MFN 059-83
JNF 018-83

March 18, 1983

SUBJECT: IN THE MATTER OF 238 NUCLEAR ISLAND
GENERAL ELECTRIC STANDARD SAFETY ANALYSIS REPORT (GESSAR II)
DOCKET NO. STN 50-447

REVISED DRAFT RESPONSES, RESPONSES TO DISCUSSION ITEMS AND
TEXT CLARIFICATIONS

Figure 6.2-48. Secondary Containment Penetration Types for Leakage Control

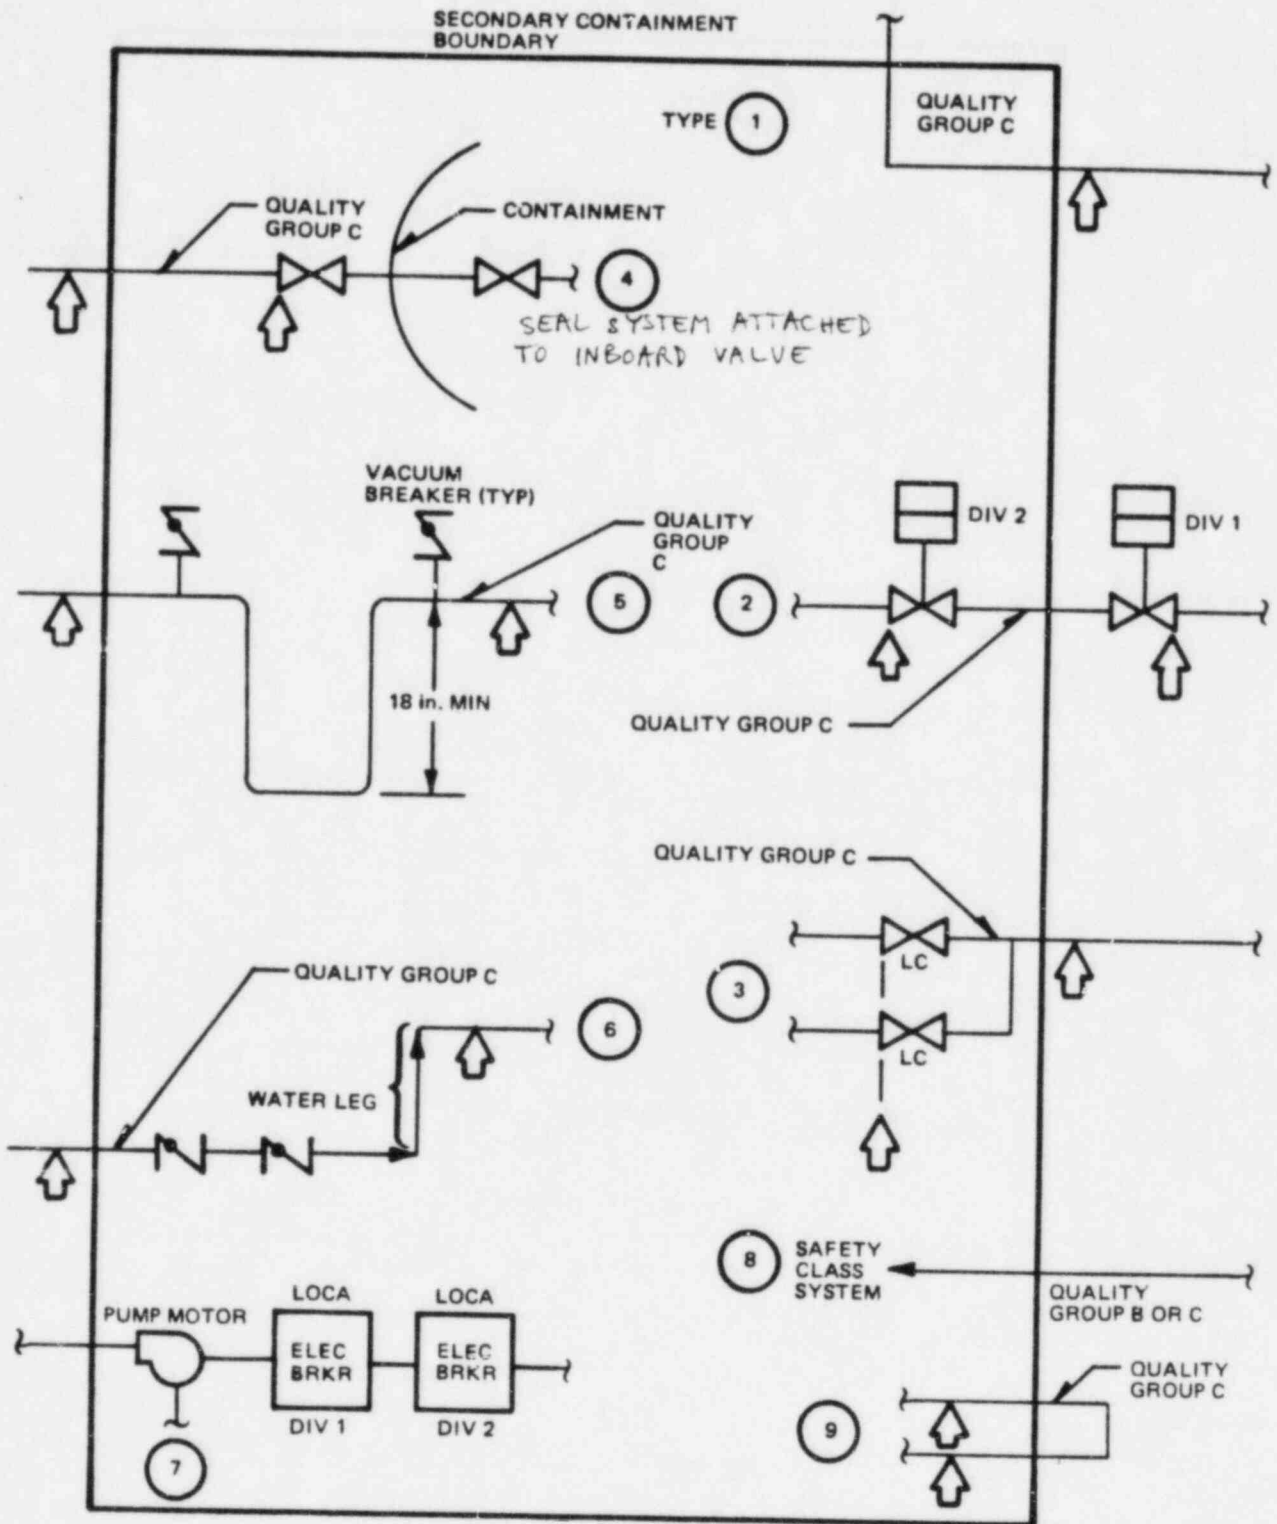
As a result of the review of potential sources of bypass leakage, changes will be made to GESSAR Tables 6.2-20 and 6.2-24, and Figure 6.2-48 to address the following subjects:

- 1) The 4" SPCU from demineralizer line will be added to secondary containment Table 6.2-20.
- 2) ^{H/CS and} ~~Eight inch~~ RCIC from condensate storage system ~~lines~~ will be added to Table 6.2-24 as a footnote. This footnote will be attached to penetration No. ~~16C and 17C.~~
- 3) A note will be added to Figure 6.2-48 on GESSAR Page 6.2-279 indicating that the Type 4 penetration has a sealing system on the inner set of valves.

Figure 6.5-11. Post-LOCA Fuel Building Pressure Response

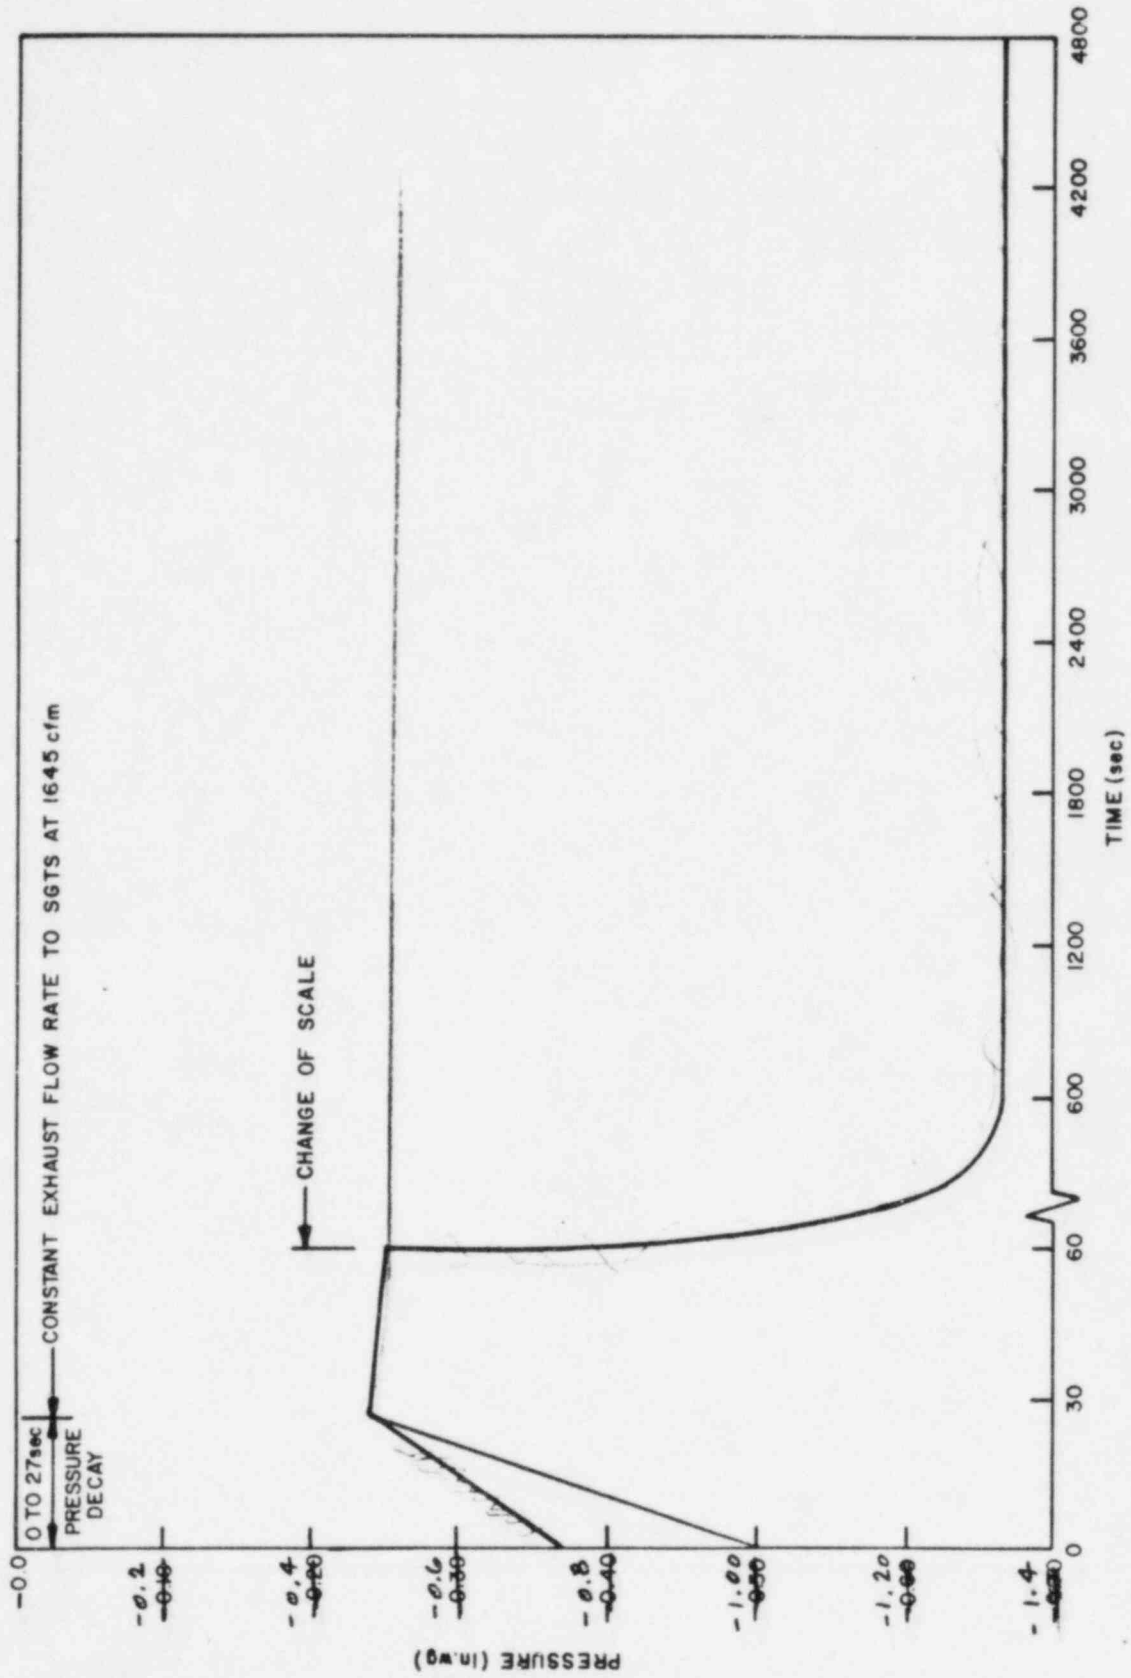
- A) Change Table G.2-19 to correct post-LOCA conditions.
- B) GESSAR changes were included in response to Item 5d. Deleted Fig. G.5-10.
- C) Clarify assumptions and add pressures to the chronological sequence in Section G.5.1.3.2.2 on pages G.5-9 and 10.
- D) Modify Fig. G.5-11

6.5.1.3.2.3 Fuel Building Pressure Response Analysis *P < (-) 0.500" w.g.*

The Fuel Building pressure control exhaust system fan maintains the Fuel Building under a negative pressure differential of ~~0.625~~ ^{1.0} in WG during normal plant operation by withdrawing the amount of air equal to the in-leakage. Ductwork connection and damper switching control are provided between the pressure control system and the SGTS. In the event of a LOCA coincidental with the loss of normal AC power, the Fuel Building pressure control system fan stops. The SGTS fan operates at its rated flow 27 sec after a LOCA and exhausts 1645 cfm continuously from the Fuel Building to maintain a subatmospheric condition. The pressure and temperature response profiles for the Fuel Building are shown in Figures 6.5-11 and 6.5-12, respectively.
